**City of Woodburn**  
**Community Development**

**Date:** August 8, 2022  
**To:** Dago Garcia, P.E., City Engineer  
**Cc:** Chris Kerr, AICP, Community Development Director  
Jamie Van Agtmael, PLS, President  
**From:** Colin Cortes, AICP, CNU-A, Senior Planner *cc*  
**Subject:** **Planning Division review comments on 2<sup>nd</sup> / 1<sup>st</sup> revised submittal June 28 of civil engineering plans for Allison Way Apts. Ph. 2**

Planning Division staff identifies revisions needed before sign-off on Public Works Department Engineering Division approval and issuance of civil engineering plans for Allison Way Apartments Phase 2 (DR 2019-05) along the east/southeast side of Allison Way south of Hooper Street.

STRIPING PLAN  
 SCALE: 1" = 40'  
 PROJECT NO: 60-10  
 SHEET: 25 OF 34

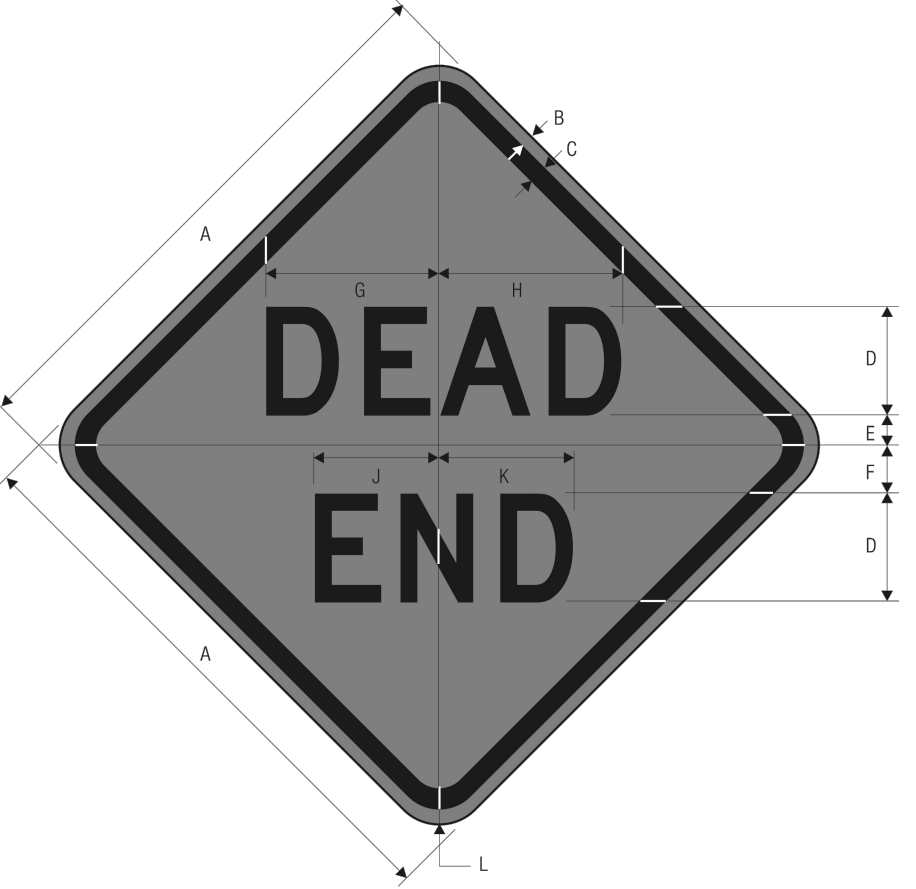
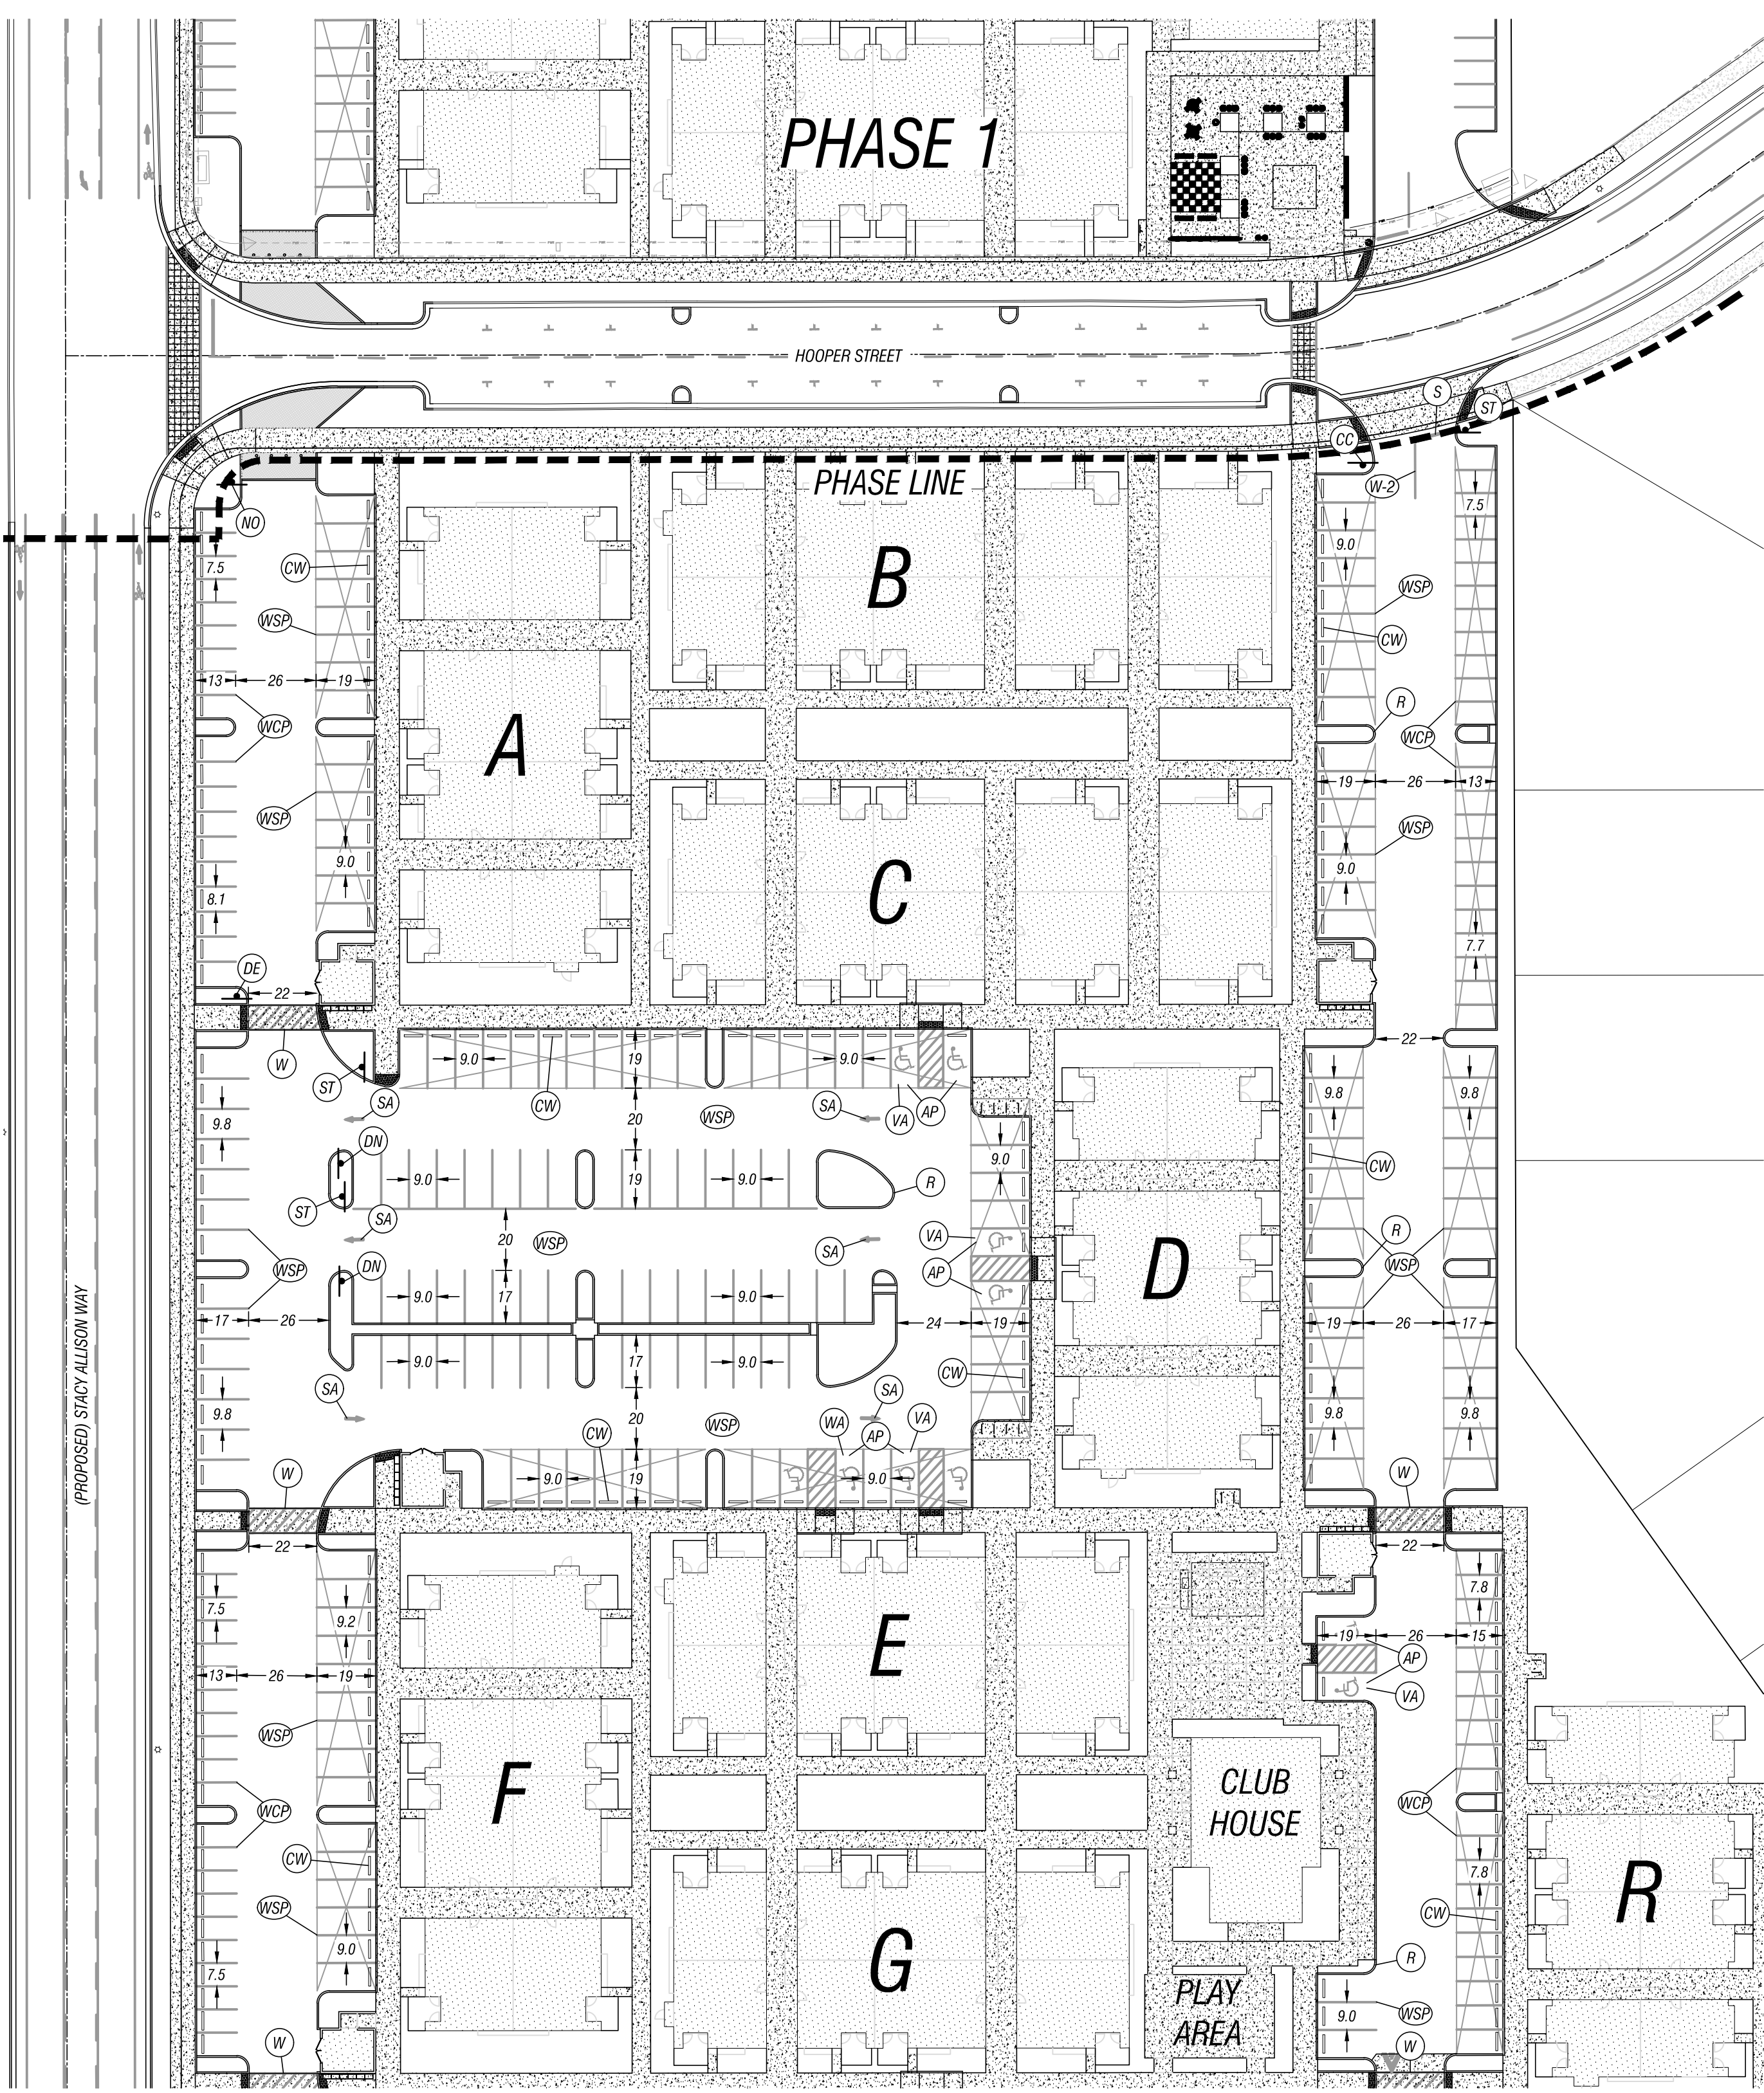
*K. Condition V9-2: Indicate number of apartments, the conditioned parking ratio of 1.9 stalls per dwelling, minimum number of stalls required, and proposed number of stalls. Revise at least Sheets UT-1 / 4 & SP-1 / 25.*

SCALE: 1" = 40'  
PROJECT NO: 60-10  
SHEET: SP-2  
26 OF 34

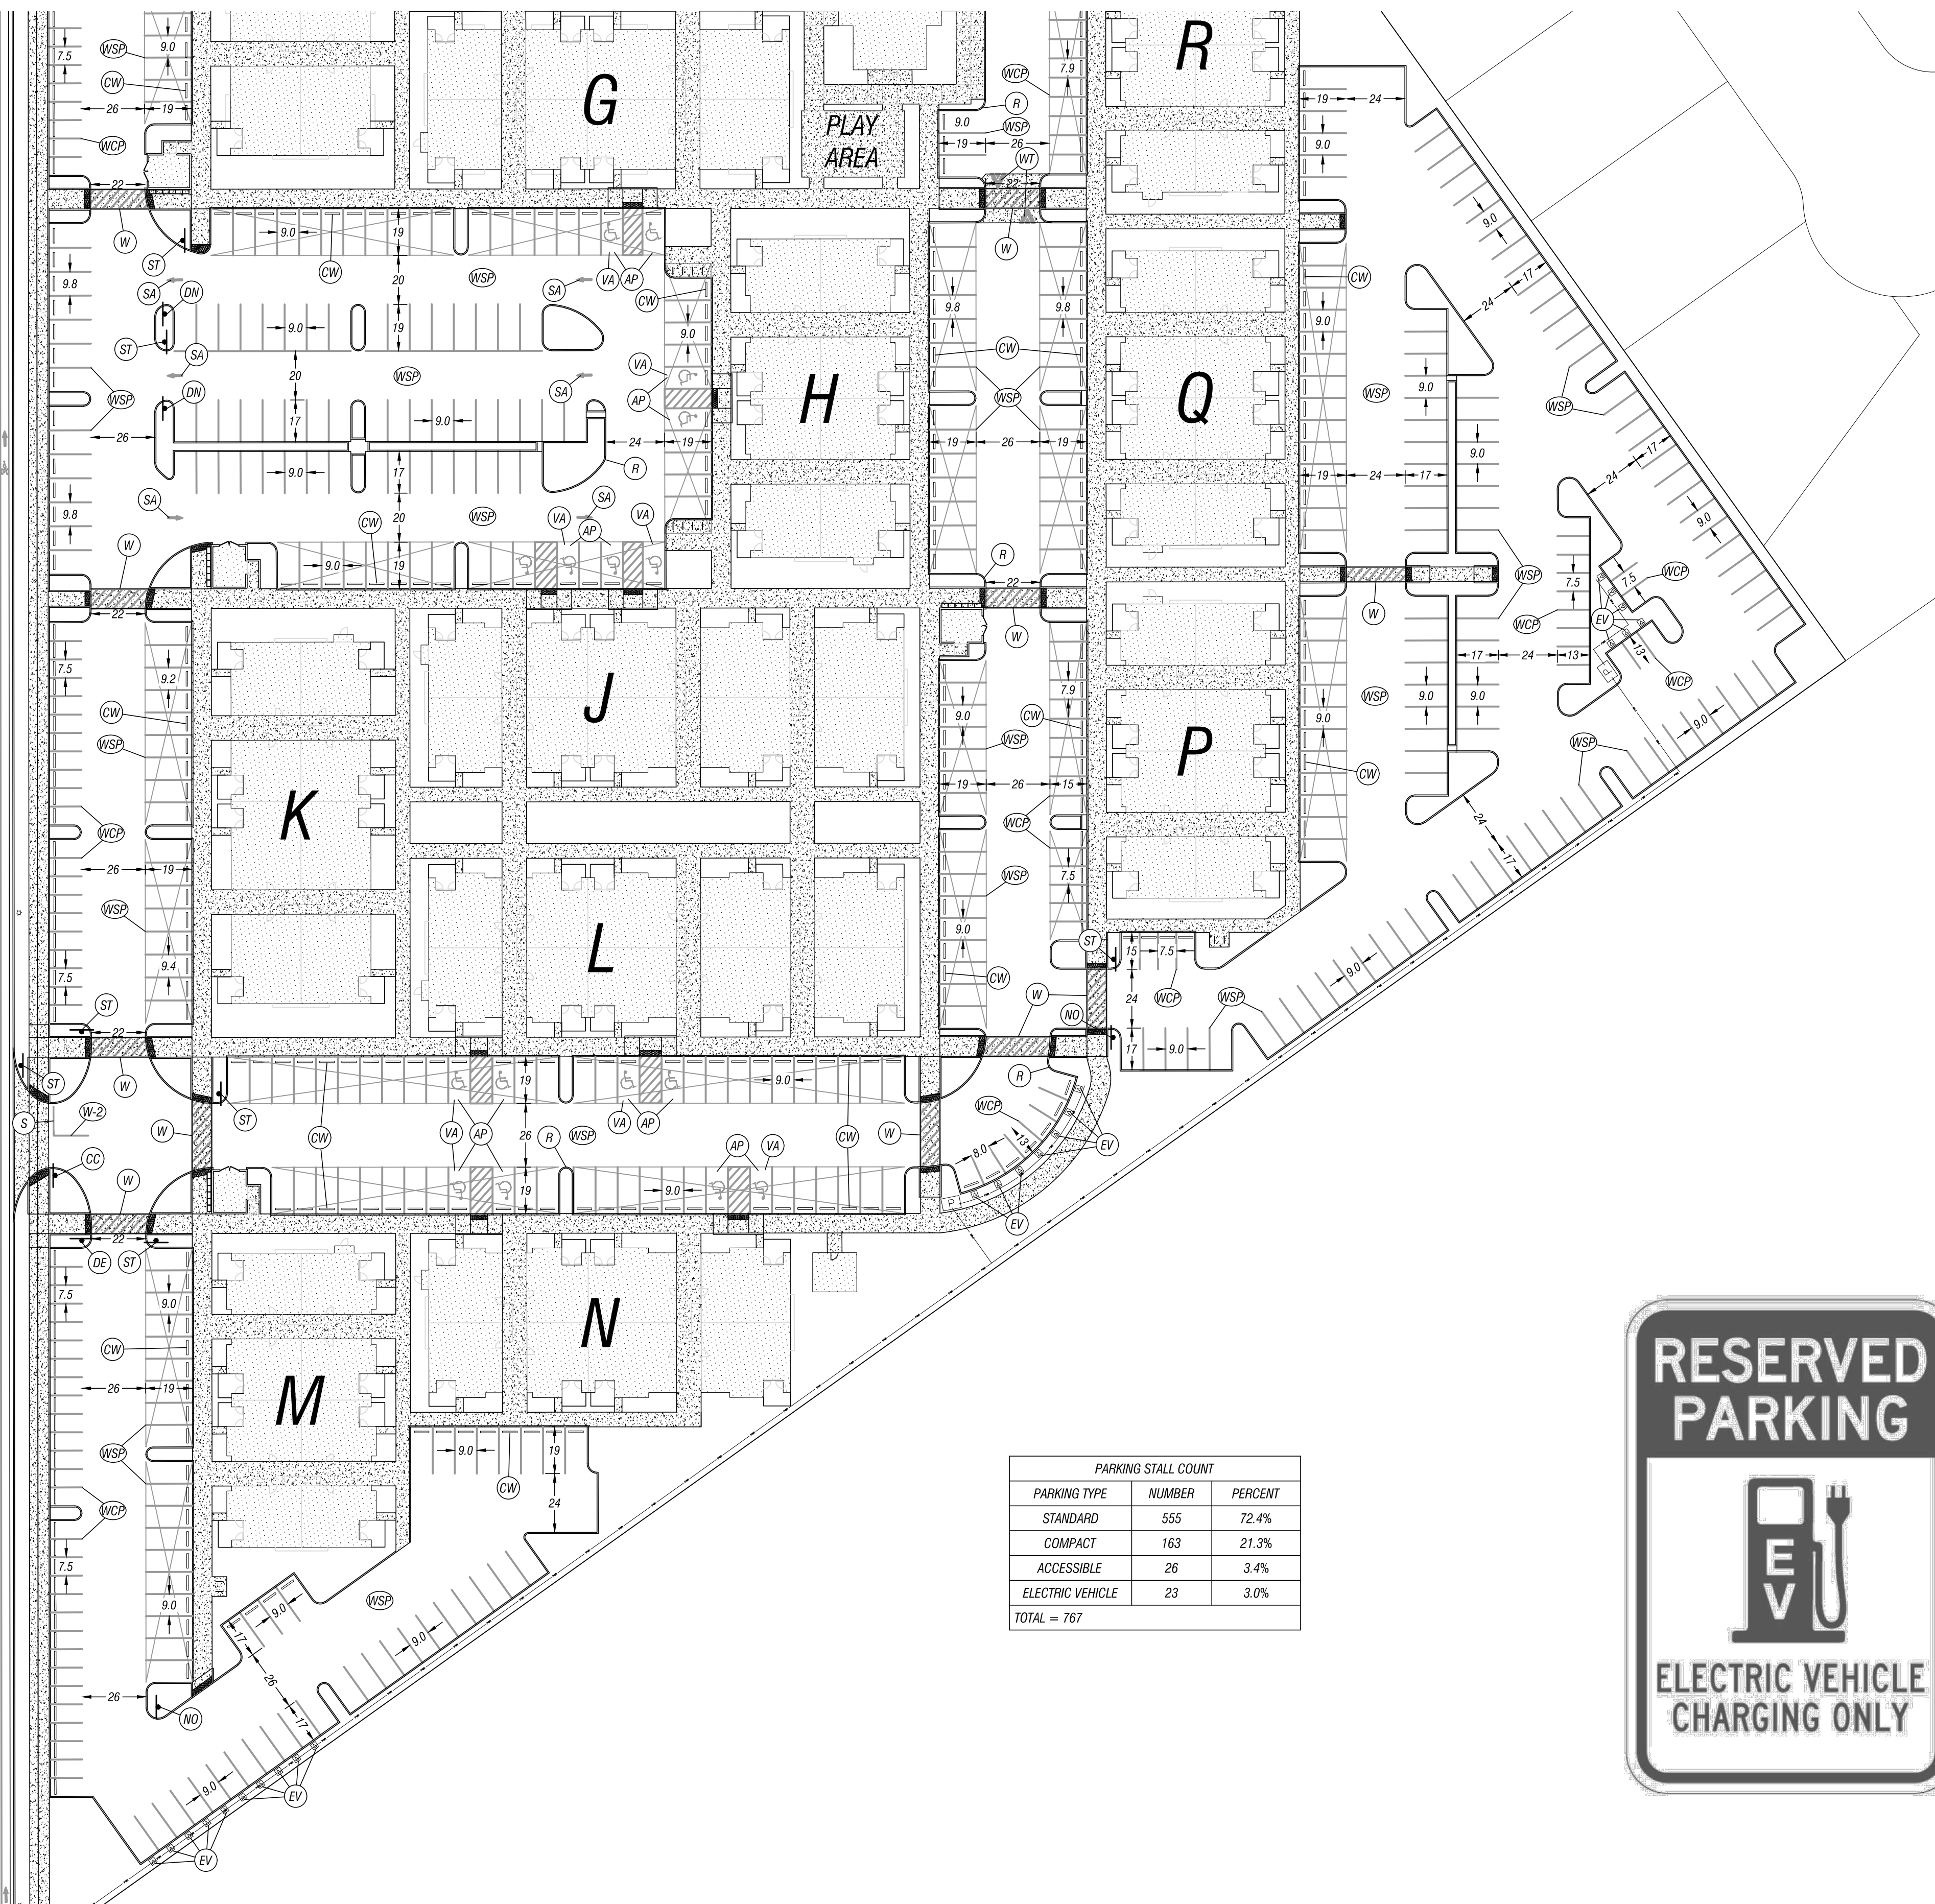
- *Part (4): Tree, shrubbery, and lawn grass details. Submit a landscaping plan sheet series.*
- *Part (8): NW side landscaping. Submit a landscaping plan sheet series.*
- *Part (9): Interim signage. Revise Sheet SP-2.*

Landscaping within right-of-way is part of public improvements and needs review at the time of CEP. Regarding condition Part (9), which sheet or sheets? It’s not obvious where.

1. The Sheet 26 center bottom table indicates 23 EV stalls; however, Condition V6-3-2e specifically set a Phase 2 minimum of 24. Revise accordingly.
2. Indicate the number of apartments in or near the table.

The developer’s letter responded that, “Landscape plans shall be submitted and reviewed at the time of building permit review. Part (9) has been met on the civil engineering plan set by adding the requested signage.”
